Addendum No. 5

City of Coquitlam

RFP No. 25-002

Burke Mountain Athletic Park Construction Services

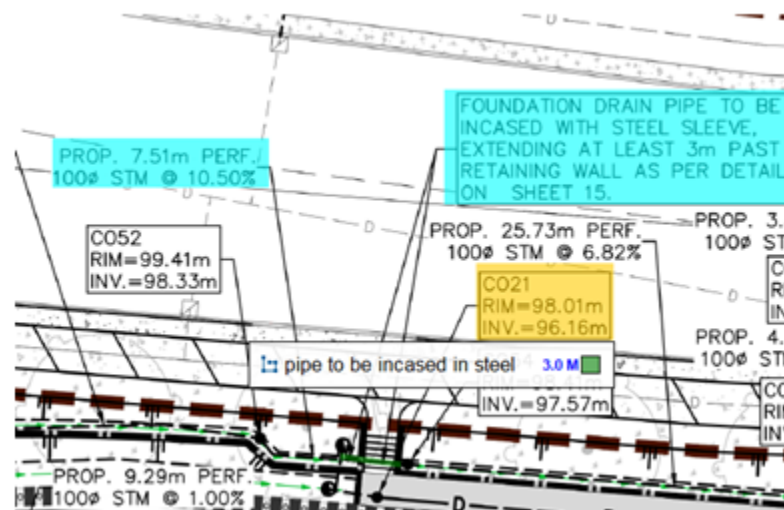
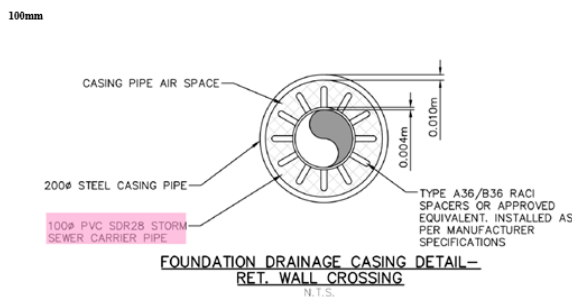
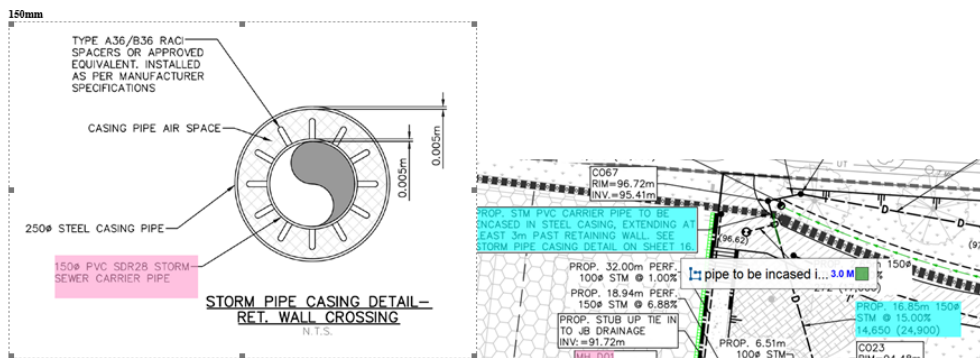
Q49. This is the Q/A in addendum #2, regarding 45 holes for the existing wall, read the description is difficult to come up with a cost, please provide drawings , sections to show how is done and how much material to be involved, for tie ins to the piping system, we need to have a location so we can find out how the pipes and tees required.

A49. No additional pipes, tie in, etc. are needed. The drainage board should be installed as described to extend a minimum of 150mm below grade and then out from the secant wall by 0.6m. The water will drain into the subgrade, and then be picked up some distance away by drains already specified on the civil drawings.
